# Access Compliance Report

## Public Rights-of-Way

### (Curb Ramps)

Intersection ID: 26017	Main Street: CARMEL COMMONS BV	Cross Street: COPERNICUS CR	Location: S
ADA ID: 269FB6B80956	Ramp Type: PerpDiag	Initial Pass/Fail: Fail	Overall Compliance: No
		Severity Score: 37.5

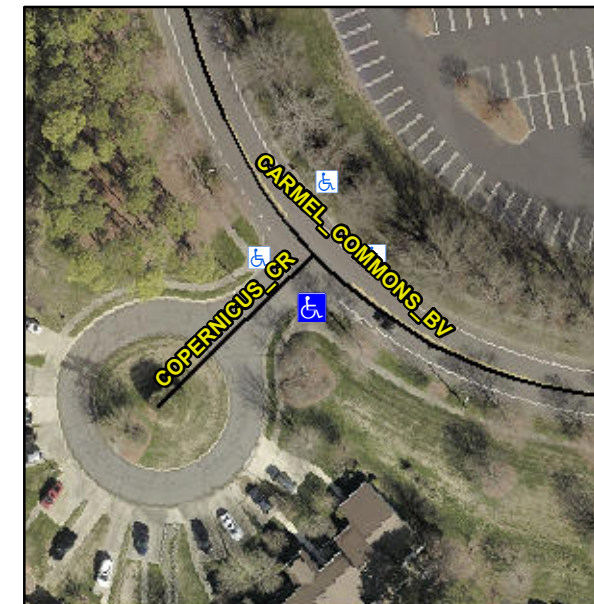
**R304.2.2, R304.5.3**

Compliance	Description	Data	Compliance	Description	Data
N/A	Ramp Length (in)	112.0	No	Ramp Slope (%)	8.7
Yes	Ramp Width (in)	54.0	No	Ramp XSlope (%)	10.5
N/A	Flare Type LT	N/A	N/A	Flare Type RT	N/A
N/A	Flare Slope LT (%)	N/A	N/A	Flare Slope RT (%)	N/A
N/A	Flare Traversable LT?	N/A	N/A	Flare Traversable RT?	N/A
N/A	Landing Length (in)	N/A	N/A	DWS Provided?	N/A
N/A	Landing Width (in)	N/A	N/A	DWS Contrast?	N/A
N/A	Landing Slope (%)	N/A	N/A	DWS Length (in)	N/A
N/A	Landing X Slope (%)	N/A	N/A	DWS Full Width?	N/A
N/A	Landing Curb? (Y/N)	N/A	N/A	DWS Offset (in)	N/A
N/A	Shared Landing?	N/A			
N/A	Gutter Ponding?	N/A	N/A	Gutter Slope (%)	N/A
N/A	Gutter Lip Ht (in)	N/A	N/A	Gutter X Slope (%)	N/A
N/A	Painted X Walk1?	No	N/A	Painted X Walk2?	No
	X Walk 1 Direction	To NE		X Walk 2 Direction	To NW
N/A	X Walk 1 Width (in)	N/A	N/A	X Walk 2 Width (in)	N/A
	X Walk 1 Slope (%)	0.5		X Walk 2 Slope (%)	3.3
	X Walk 1 X Slope (%)	3.6		X Walk 2 X Slope (%)	0.2

**Remove & Replace Curb Ramp With Two New Directional Ramps or Equivalent.**
